April 4, 2007
Alan Ballweg
New Design Electronics LLC

Stat Version 2 (RTSv2) Permissive Change Request

Description of changes

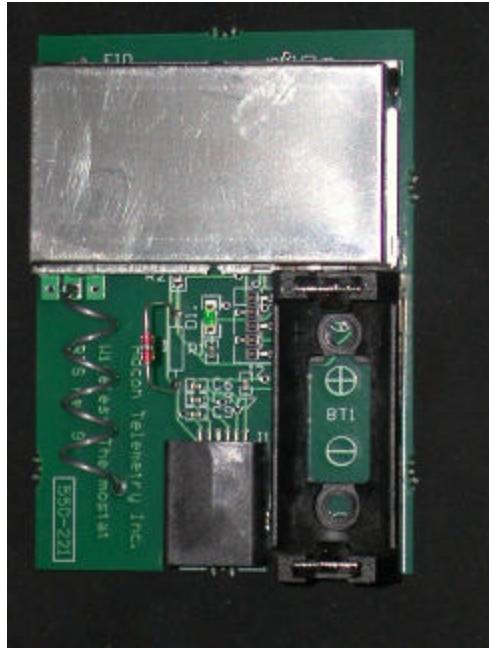
The changes involve the addition of two features to the motherboard.

The two additional features are a mechanical slider (“Setpoint”) which permits the user to set the desired temperature, and a pushbutton (“Override”) which permits the user to override the current settings.

To accommodate these changes, the layout of the motherboard was changed, however *the radio module and its transmission characteristics were not modified in any way.*

The changes involved the addition of seven resistors to the motherboard (R6-R12, see schematic), as well as the mechanical slider and pushbutton. No other components were added, removed, or changed.
